# Access Compliance Report

## Public Rights-of-Way

### (Curb Ramps)

Intersection ID: N/A	Main Street: BALLANTYNE CORPORATE PL	Cross Street: N/A	Location: NE
ADA ID: B60AB098FA08	Ramp Type: Directional	Initial Pass/Fail: Fail	Overall Compliance: No
Codes/Mitigation Info/Possible Solution		Field Measurements/Component Compliance	
Severity Score: 21.25

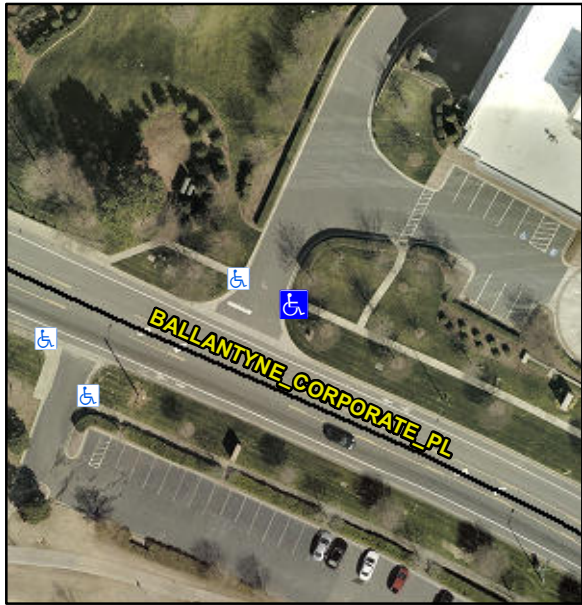
R304.5.1, R304.2.2

Compliance	Description	Data	Compliance	Description	Data
N/A	Ramp Length (in)	76.0	N/A	Grade Break?	N/A
No	Ramp Width (in)	47.0	N/A	Grade Break Slope (%)	0.0
No	Ramp Slope (%)	8.6	N/A	Grade Break XSlope (%)	0.0
Yes	Ramp XSlope (%)	1.9			
N/A	Flare Type LT	N/A	N/A	Flare Type RT	N/A
N/A	Flare Slope LT (%)	N/A	N/A	Flare Slope RT (%)	0.0
N/A	Flare Traversable LT?	N/A	N/A	Flare Traversable RT?	N/A
N/A	Landing Length (in)	0.0	N/A	DWS Provided?	N/A
N/A	Landing Width (in)	0.0	N/A	DWS Contrast?	N/A
N/A	Landing Slope (%)	0.0	N/A	DWS Length (in)	N/A
N/A	Landing X Slope (%)	0.0	N/A	DWS Full Width?	N/A
N/A	Landing Curb? (Y/N)	N/A	N/A	DWS Offset LT (in)	N/A
N/A	Shared Landing?	N/A	N/A	DWS Offset RT (in)	N/A
N/A	Gutter Ponding?	0.0	N/A	Gutter Slope (%)	N/A
N/A	Gutter Lip Ht (in)	0.0	N/A	Gutter X Slope (%)	N/A
N/A	Painted X Walk1?	No		Road Slope (%)	2.3
	X Walk 1 Direction	To NW		Road X Slope (%)	2.4
	X Walk 1 Width (in)	N/A		Clear Space?	N/A

X Walk 1 Slope (%)	2.3	N/A	Clear Space to XWalk (in)	N/A
	X Walk 1 X Slope (%)	2.4	N/A	Storm Grate/Utility Hazard?	N/A
N/A	Ramp inside XWalk1?	N/A		Storm Grate/Utility Type	
N/A	Any Obstructions?	N/A			N/A
	Obstruction Type		Yes	Surface Condition? (G/P)	Good
		N/A	N/A	Curb Slope (%)	6.0

Remove & Replace Entire Ramp.
